BAR Meeting  
January 5, 2011

**ISSUE:** Permit to Demolish/Encapsulate & Certificate of Appropriateness  
(Addition and Alterations)

**LOCATION:** 408 South Royal Street

**BAR CASE #2010-0364**  
**#2010-0365**

Figure 6: Proposed Front (West) Elevation

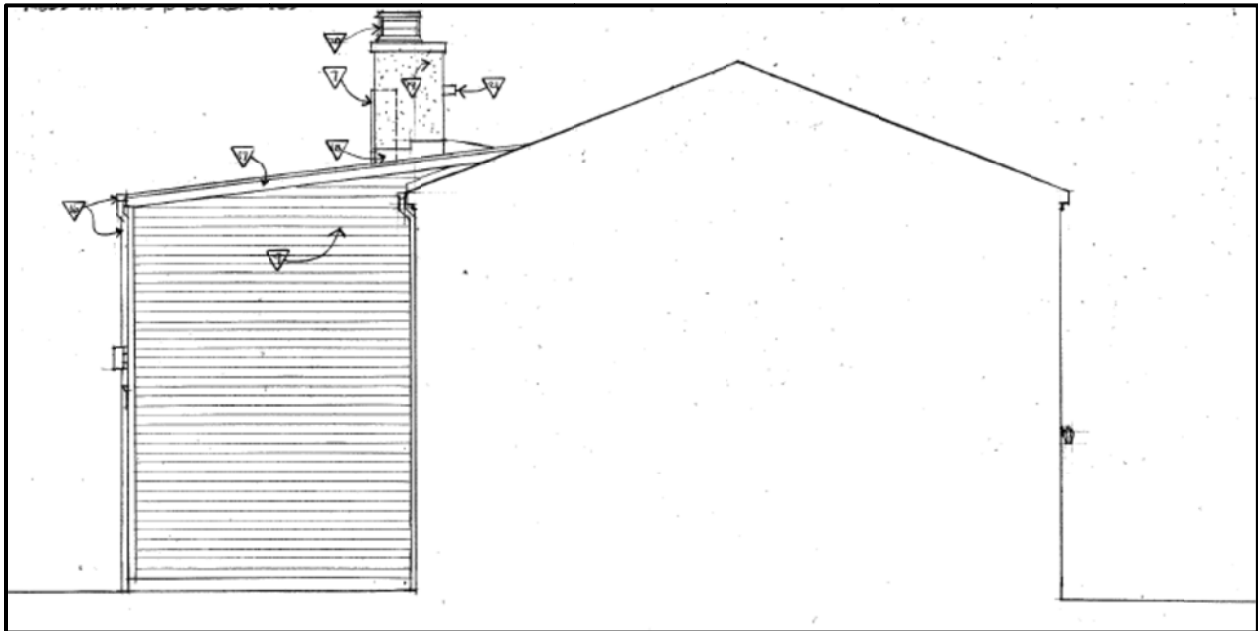
Also on the front elevation, the applicant proposes to remove the non-historic wood shutters, 6/6 wood windows, and six panel door and replacing these materials with historically appropriate detailing such as painted 2/2 wood windows, painted, four panel doors, and the re-installation of a single light transom.<sup>1</sup>

The applicant’s proposal to remove the existing 6/6 windows, the six panel door, the applied shutters and re-install a transom above the entry will be a great improvement, as these details are not original to the first period of construction. Based on research performed by Alexandria Archaeology, this house along with its pair at 406 was constructed in the mid-1870s, to replace a pair of frame structures. The utilization of Victorian detailing such as 2/2 painted wood windows and four-panel wood doors are more appropriate material selection for this date of construction. The planter to be removed from the ROW is currently abutting the historic

1. That the trim utilized on the addition will be solid through the core, paintable PVC trim.
2. That the fiber cement siding be smooth (rather than with a simulated woodgrain) and the nails are installed recessed.

Figure 9: Proposed Rear (East) Elevation

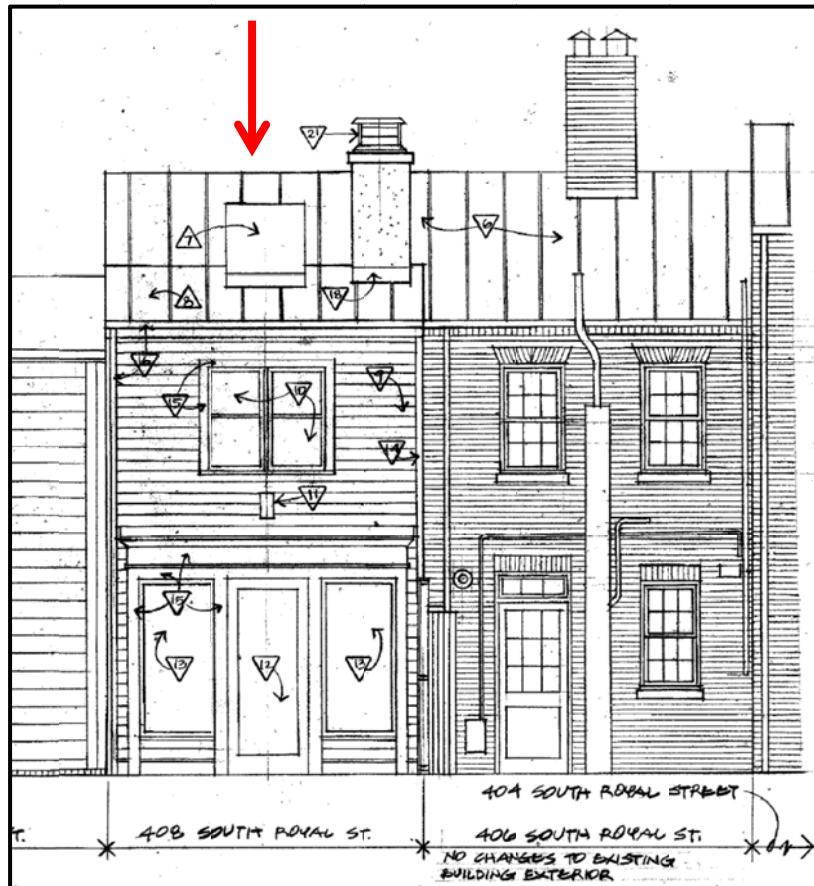
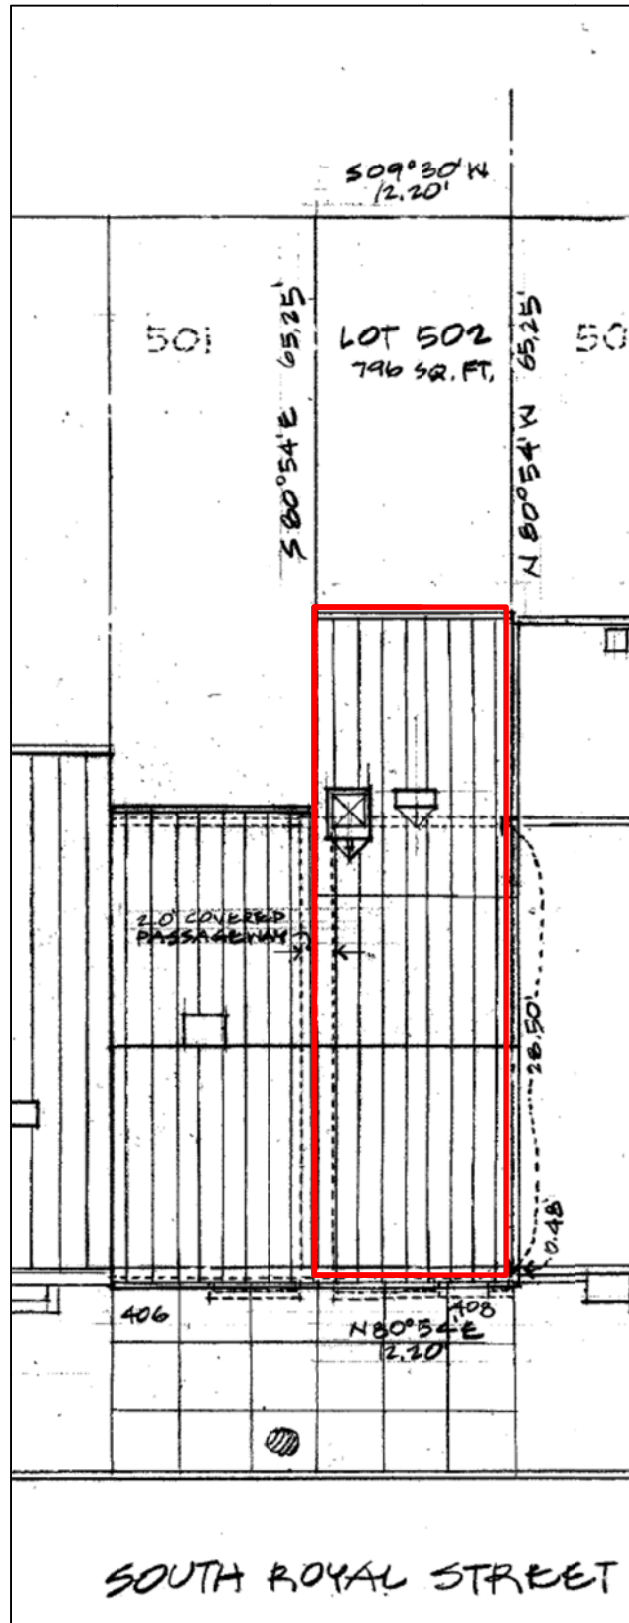
- Demolish 56 square feet of the brick wall on the first and second floors (112 sq. ft total) and reconstruct 14 square feet of the first floor and 21 square feet of the second floor wall utilizing the historic brick. After reconstruction, there will only be approximately 77 square feet of wall surface demolished.
- 237.5 square feet to be encapsulated on the first and second floors of the rear elevation

In the opinion of Staff, this late-19<sup>th</sup> century townhouse is architecturally significant to the overall historic district and compatible with nearby historic structures. The proposed encapsulation is at the rear of the building, minimal in scope and not visible from the public right-of-way. Additionally, the elevation to be demolished/encapsulated is simple in detailing and without unusual or character defining elements or unique architectural features. As such, the demolition/encapsulation will not have an adverse effect on the historic resource or a negative impact on the district as a whole. It is for these reasons Staff believes none of the criteria for demolition and encapsulation are met and the Permit to Demolish/Encapsulation should be granted.
